UNITED STATES PATENT AND TRADEMARK OFFICE

Office Action Summary

10/784,958

SUZUKI ET AL.

Figure 1A.

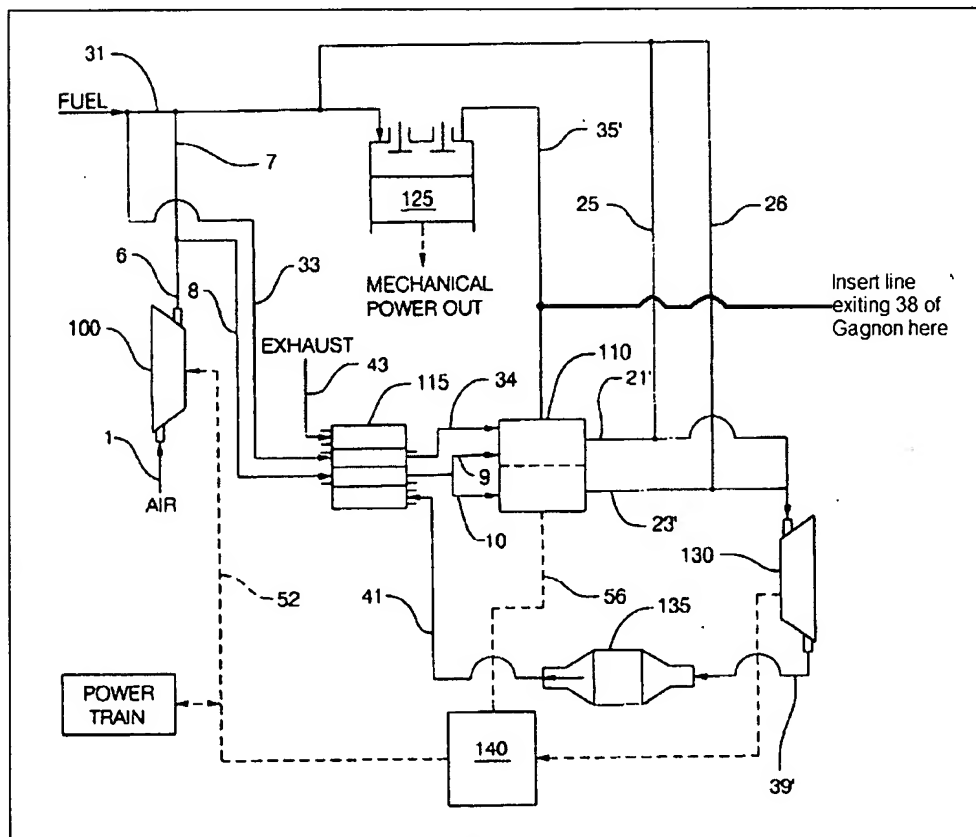
amount of fuel supplied to the fuel cell based on the demand of the system (Abstract; Col. 2, Lines 1-10). It would have been obvious to one having ordinary skill in the art at the time the invention was made to utilize the fuel control system as taught by Gagnon in the system of Botti by inserting the Gagnon system at the location illustrated in Figure 1A below, for the advantage of excellent transient response in the system (Col. 1, Lines 66-68).

17. In regards to claim 7, the modified Botti, as described above, discloses the internal combustion engine with a fuel cell in an exhaust system as set forth in claim 1, and further comprising a combustion device, wherein the fuel supply system supplies an exhaust gas discharged from the combustion device to the exhaust passage at a location downstream of the internal combustion engine and upstream of the fuel cell (Figure 1A; Gagnon; Fig. 1, No. 36; Col. 3, Lines 29-61).

18. In regards to claim 8, the modified Botti, as described above, discloses the internal combustion engine with a fuel cell in an exhaust system as set forth in claim 7, and further wherein the fuel supply system supplies the exhaust gas discharged from the combustion device to the exhaust passage at a location downstream of the internal combustion engine and upstream of the fuel cell (Figure 1A), with combustion in the

20. In regards to claim 19, the modified Botti, as described above, discloses the internal combustion engine with a fuel cell in an exhaust system as set forth in claim 7, and further comprising a heat exchanger installed on the exhaust passage at a location downstream of the fuel cell (Figure 1A, No. 130), and an air supply passage that has the heat exchanger installed thereon and is connected with the combustion device (Gagnon; Fig. 1, No. 74).
